# **Transpower's Net Zero Grid Pathways stage one major capex proposal**

**Final decision and reasons paper**

**Date of publication:** 28 February 2024

**Figure D1 Comparison of EDGS 2019 energy demand forecasts, 2021 EDGS variations and proposed NZGP1 energy demand forecasts<sup>301</sup>**

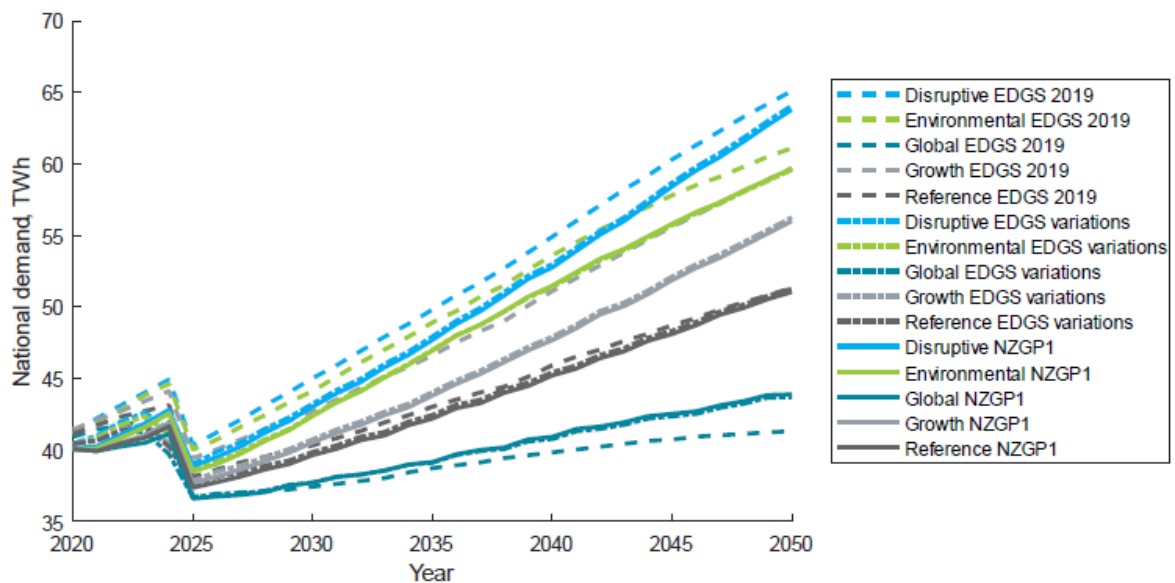
- D38 Figure D1 shows that the resulting energy demand curves for the five NZGP1 energy demand scenarios are similar to the original MBIE 2019 energy demand curves. The demand adjustments have produced a small decrease in the energy demand forecast for all scenarios, resulting in, on average, a reduction of 6 TWh in each scenario by 2050.

**Figure D2 HVDC transfer analysis with and without Tiwai smelter exit assumption**

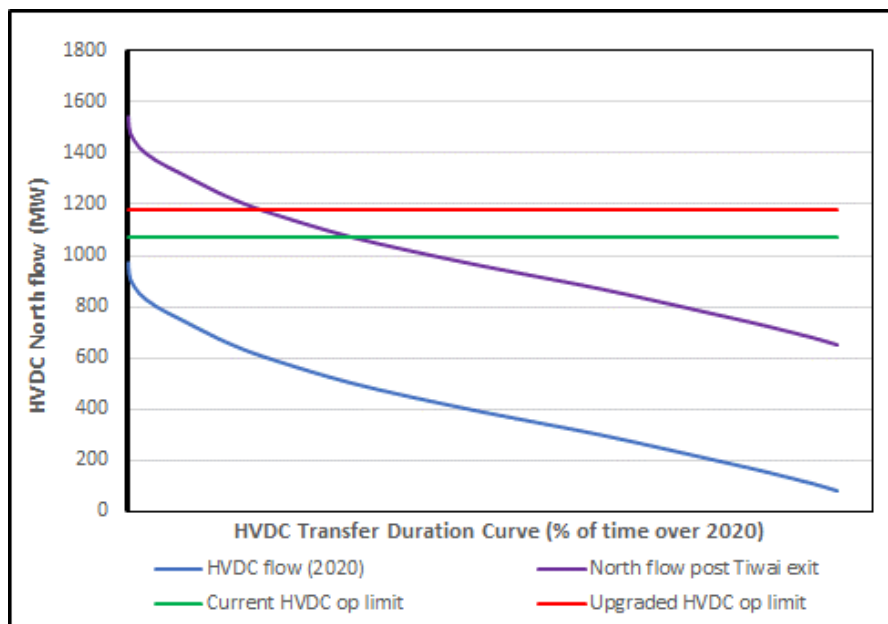
D173 Figure D2 is a power transfer duration curve analysis with the highest DC power transfer to the lowest, plotted over the year, in this case 2020. The light blue curve is the 2020 HVDC power transfer duration data supplied by Transpower. As an upper bound assumption, we added the generation surplus created by Tiwai smelter exit onto the 2020 HVDC power transfer data to create a post-Tiwai exit power transfer duration curve (the purple curve).

D174 Figure D2 shows the percentage of time HVDC north flow (the purple curve) could be greater than the current 1071 MW transfer level if the Tiwai smelter were to exit. We estimated that there could be surplus South Island generation available to transfer north about 25% of the time, above the present estimated capability of 1071 MW.

- D176 We can use the graph in Figure D2 to illustrate what a constrained HVDC is likely to cost as an upper bound. The potential constrained off energy is denoted by the area enclosed by the y-axis and the green and purple lines. The NZGP1 stage one investment would reduce the constrained off energy generation by the area enclosed by the green, red, and purple lines. This reduction provides what could be considered a likely upper bound benefit of enhancing the HVDC based on 2020 dispatch patterns.

**Figure D3 Hydro spill estimates for the Clutha, Waitaki and Manapouri hydro catchments**

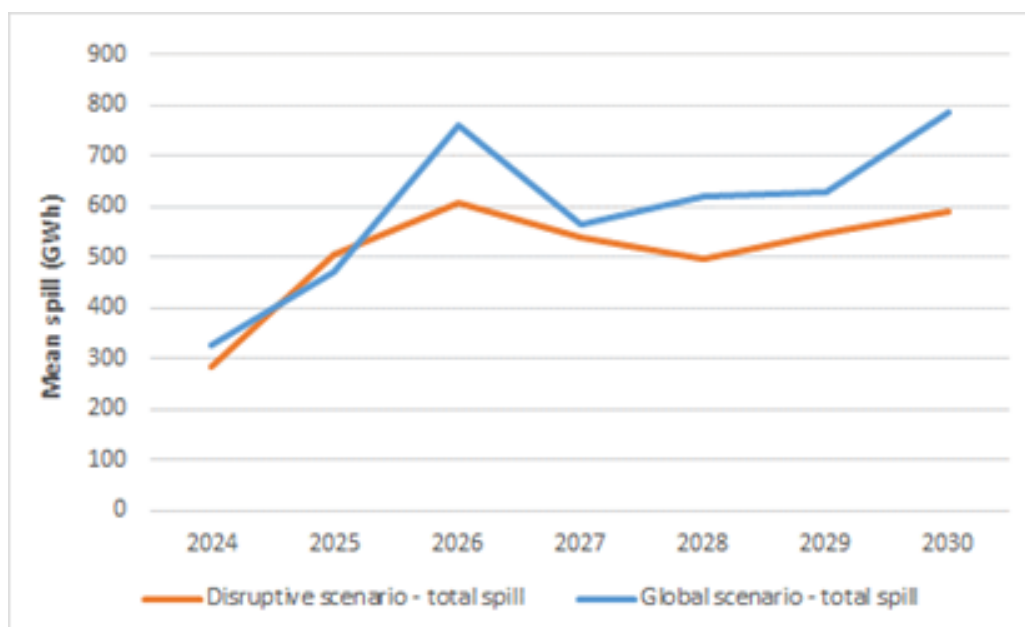
D184 Figure D3 illustrates that there is South Island hydro spill estimated in 2024, which is before the Tiwai smelter is modelled to depart in Transpower’s scenarios. In our review, we were interested in the effect of the NZGP1 stage one HVDC upgrade on the hydro spill estimate and whether this upgrade makes spill any less likely.

D185 Figure D3 illustrates that, while the modelled hydro spill drops after 2025, between 2025 and 2030 it oscillates between 500 GWh and 800 GWh depending on the scenario. There appears to be no noticeable trend that clearly shows the NZGP1 stage one HVDC upgrade provides material savings in potential hydro spill. Transpower also made this observation in response to our questions.<sup>350</sup>

**Figure D4 Undiscounted gross benefits by time for the growth scenario**

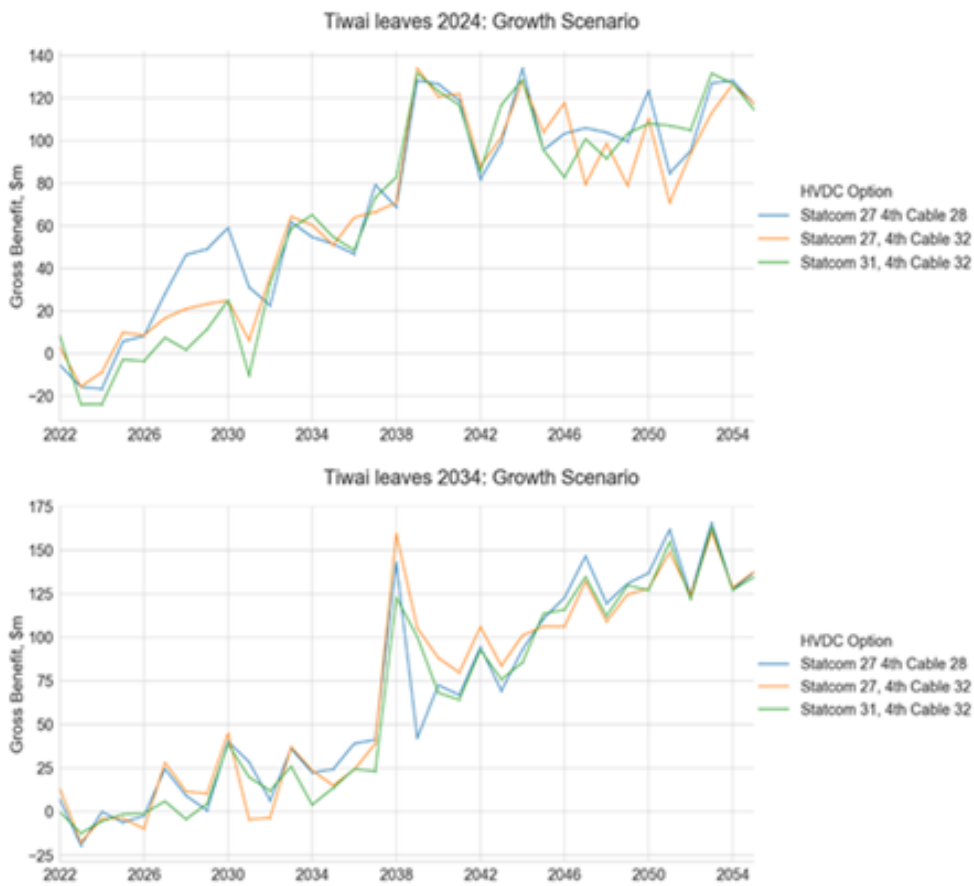
- D203 With reference to Figure D4, the blue line denotes the gross benefits where the HVDC stage one and stage two are commissioned in 2027 and 2028 respectively. Under this investment scenario, the HVDC upgrade will provide STATCOM redundancy benefits when the synchronous condensers are out of service for maintenance.

- D205 Based on our observations of the Transpower analysis, Figure D4 illustrates that:
- D205.1 most of the redundancy benefits arise only if Tiwai closes in 2024 and HVDC stages one and two are delivered in time for the synchronous condenser refurbishment works to occur;

D205.3 after 2031, there does not appear to be any significant redundancy benefits in either of the two scenarios shown in Figure D4.

D206 Figure D4 also shows some separation between the green and the blue and orange lines for the case where Tiwai remains until 2034. However, the quantum of the separation is less and only for two years.

D207 Our qualitative analysis of Figure D4 does not give us confidence that it is beneficial for HVDC stage one to be installed as soon as possible, given that the Tiwai smelter closure by 2024 is uncertain, highlighted by Transpower's most recent Tiwai smelter exit assumption in its 2023 Transmission Planning Report.

**Figure D5 HVDC operational capability, HVDC flow and BEN-HAY price differences for 2020**

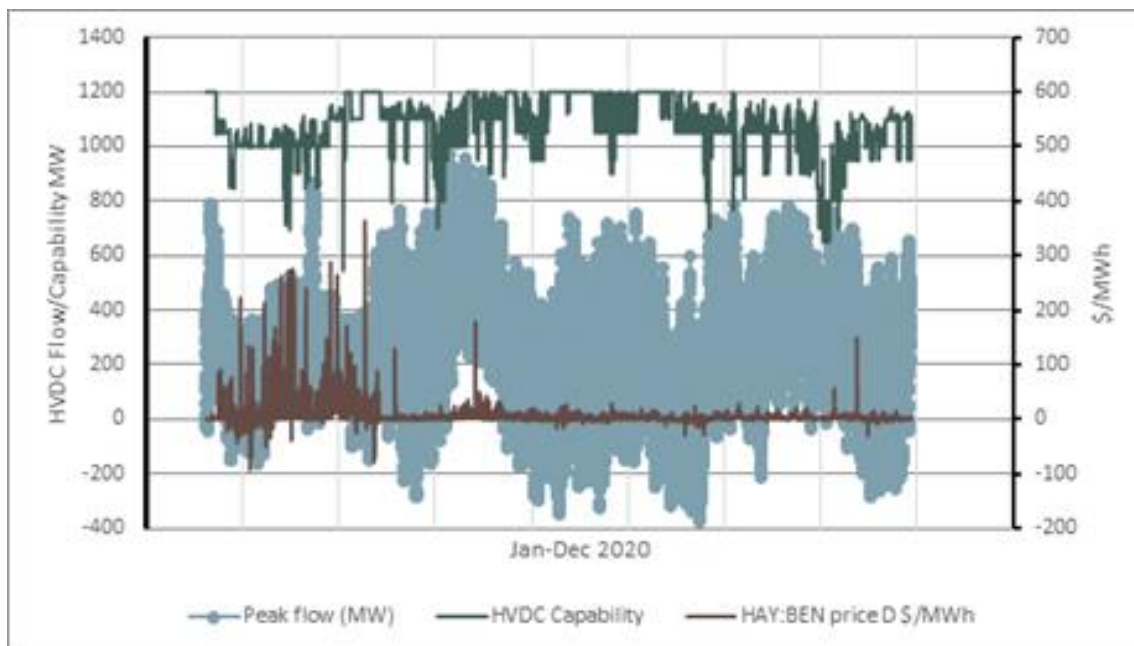
D213 We assume that if the Benmore – Haywards price difference is material, HVDC north flow will be high and/or HVDC operational capability reduced, then the unavailability of the Haywards synchronous condensers could be constraining HVDC transfer levels and affecting the market price.

D214 Figure D5 indicates that:

D215 We conclude that the observations from the Figure D5 analysis support our interpretation of the analysis in Figure D4. This indicates that the redundancy benefits of the HVDC stage one investment may be marginal until the Tiwai smelter departs.
